HDU – 200 EMS Part Number 1541-A-3000

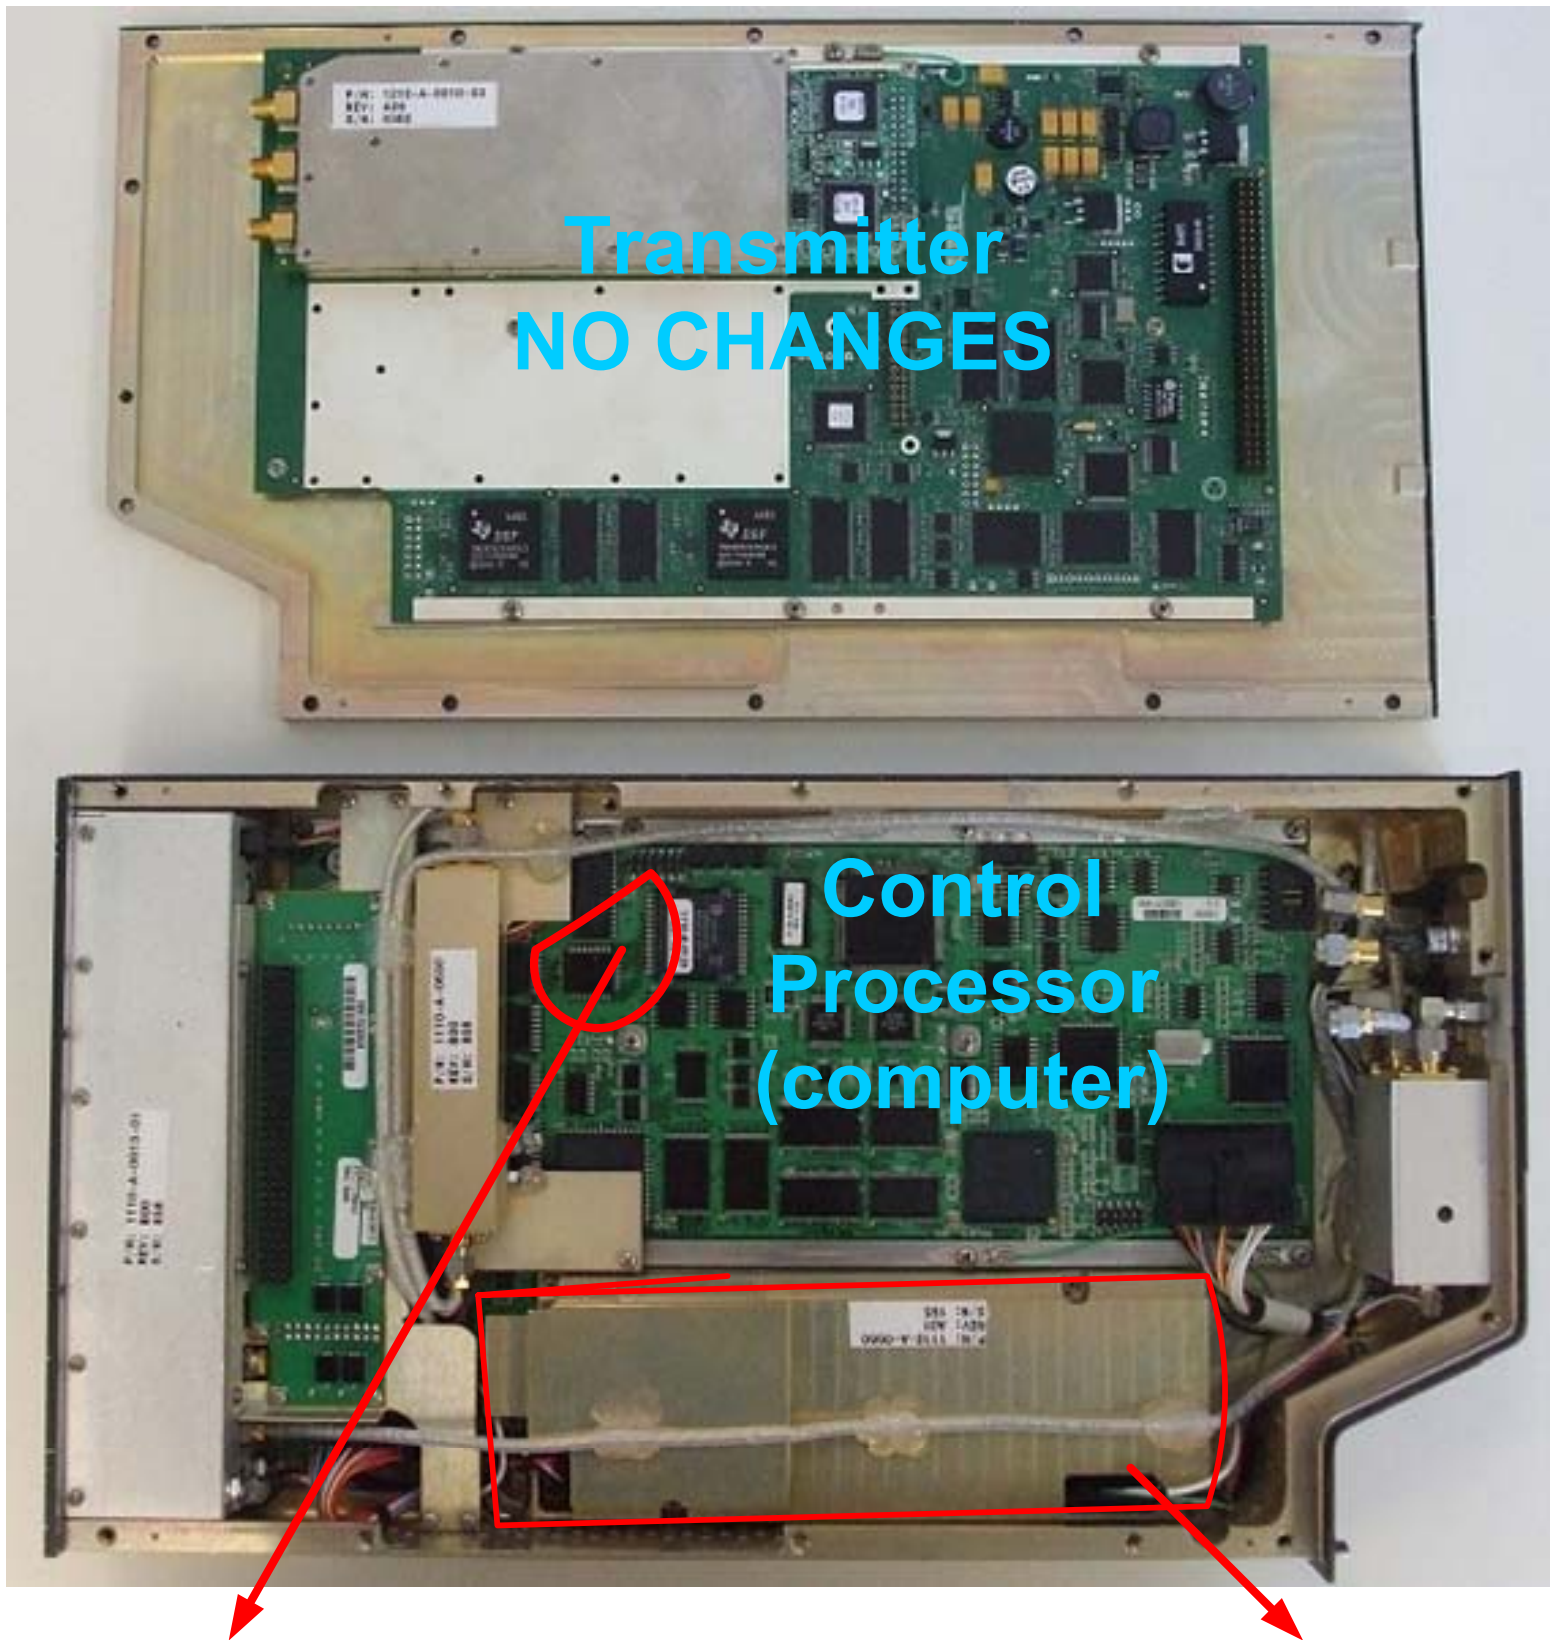
Memory for processor has been added in this section of the Control Processor (computer)

Power Supply Input has changed from 115Vac to +28VdC input. All internal voltages to the cards remain the same.
